RESPONSE TO SUBMISSIONS

**ALESCO SENIOR COLLEGE
27 CHAPMAN STREET, CHARLESTOWN
LOTS 18, 19, 20 DP23975**

4 NOVEMBER 2020

LANDSCAPE PLAN COURTYARDS 1 & 2

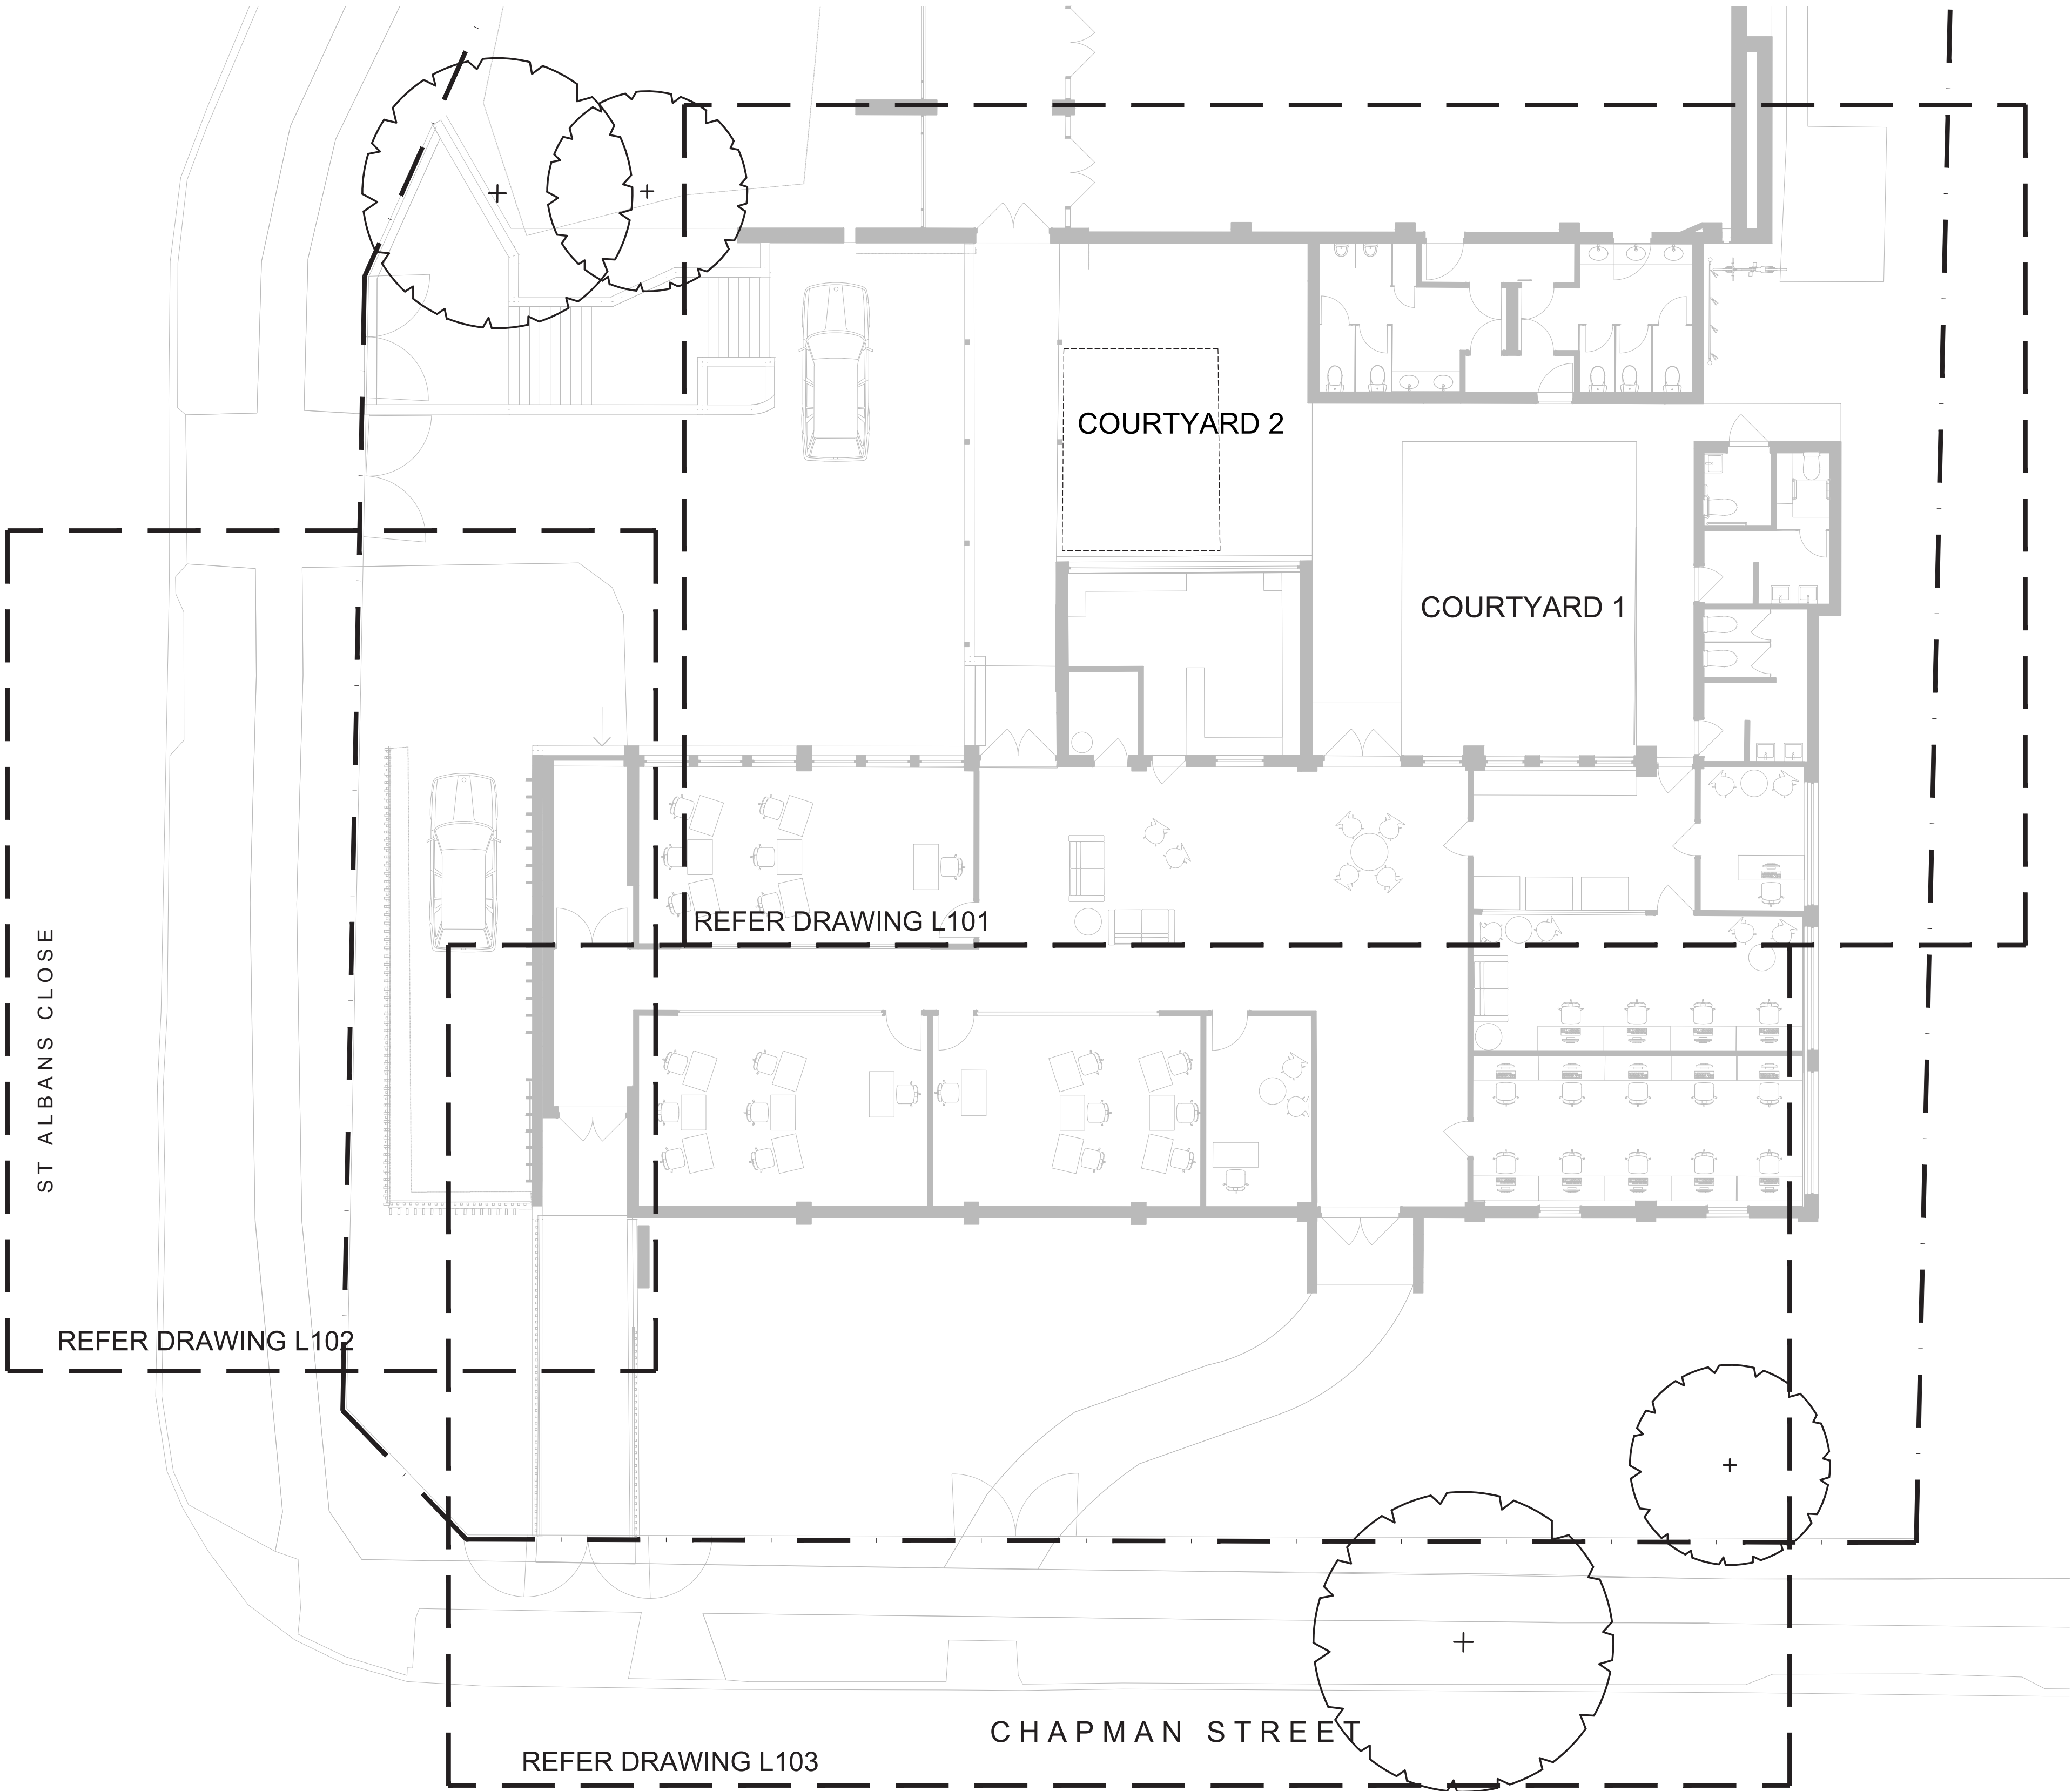
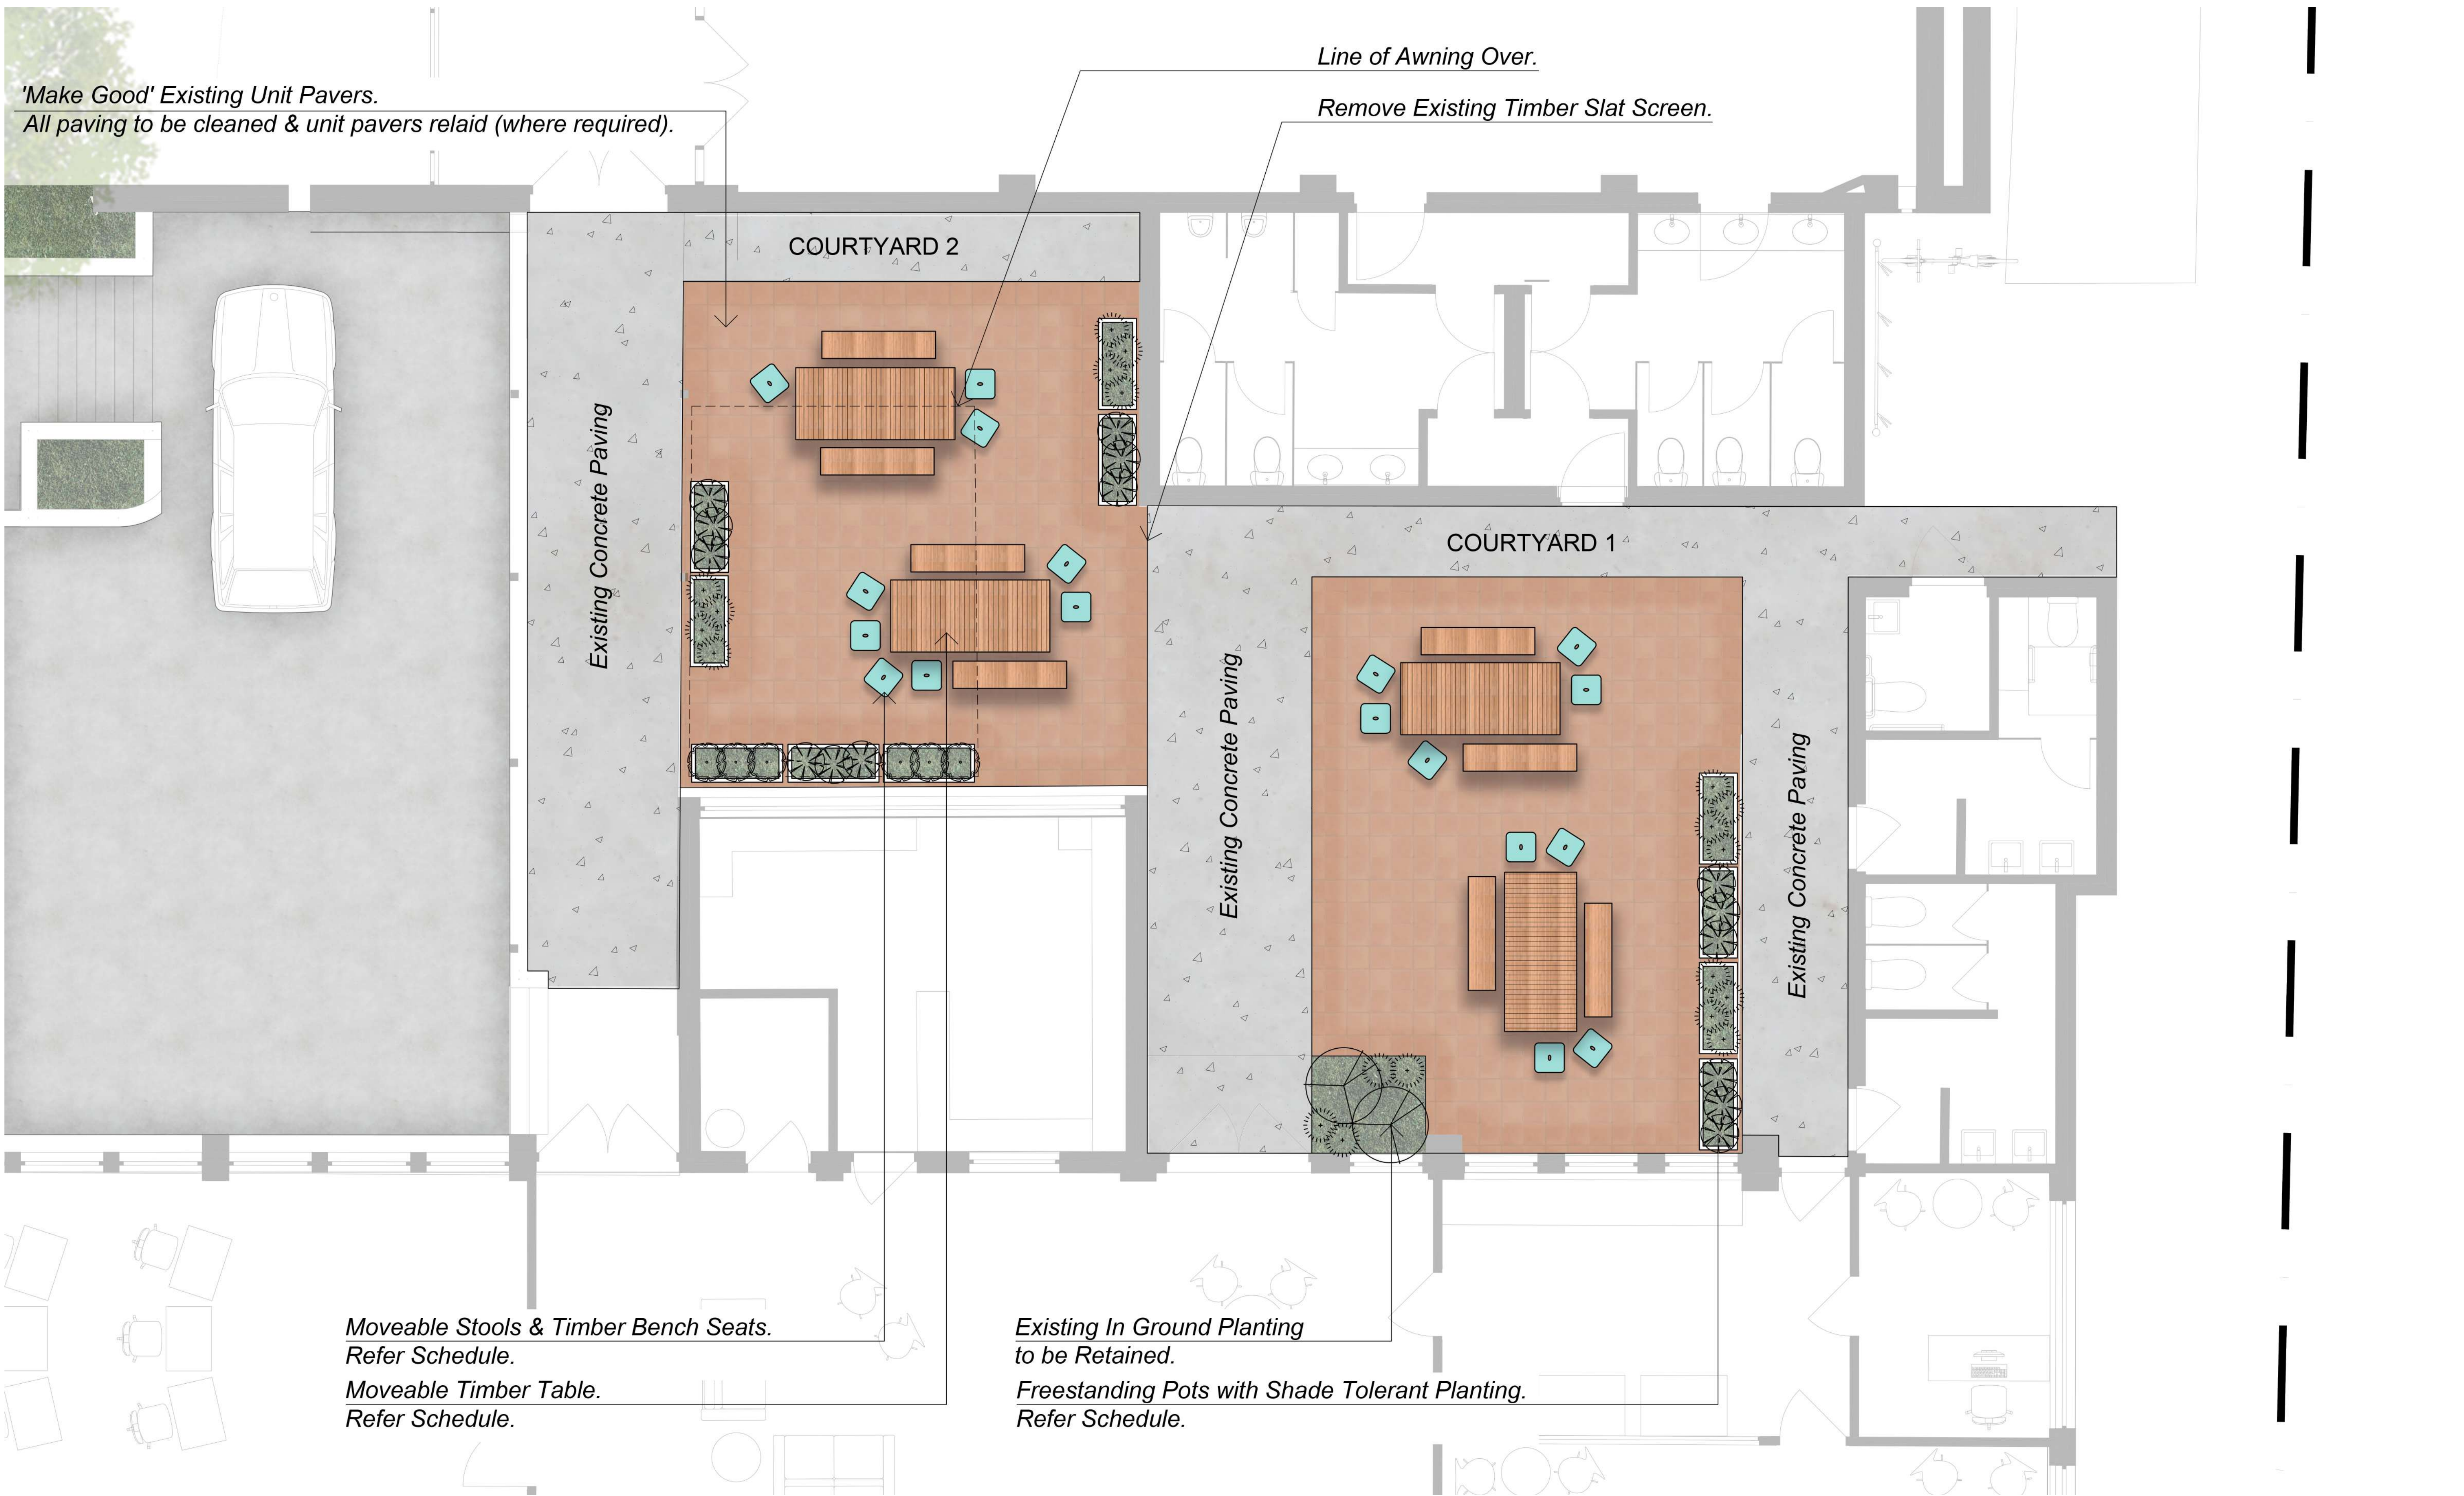
Lake Macquarie City Council	Signage	
	The EIS states that the proposal does not seek detailed planning approval for any signage. It is therefore requested that the “New Signage” notations and proposed signage zones shown on the architectural plans submitted for approval be removed (specifically for DA-2001 and DA-3001) and these plans re-issued as part of the Response to Submissions	A detailed assessment of the signage against the requirements of SEPP64 – Advertising and Signage has been completed. Accordingly, it is now requested that the proposal does seek planning approval for the signage.
	Landscaping	
	<p>The Landscape Plan should include more periphery plantings including:</p> <ul style="list-style-type: none"> • A minimum of one 75 litre planted on the south western corner of the site and eastern side of the pedestrian ramp; • A minimum of two 75 litre trees planted within the front setback to Chapman Street • One 75 litre street tree that is centred between the existing inlet pit and driveway on St Albans Close. The street tree shall be species Eucalyptus sideroxylon ‘Rosea’ planted as per LSD-PLA-02 of Lake Macquarie City Council Standard Landscape Drawings (Tree pit with stakes in turf verge) 	Refer to the updated Landscape Plans included in Attachment 2 to this document, which now show the trees as requested by Council.
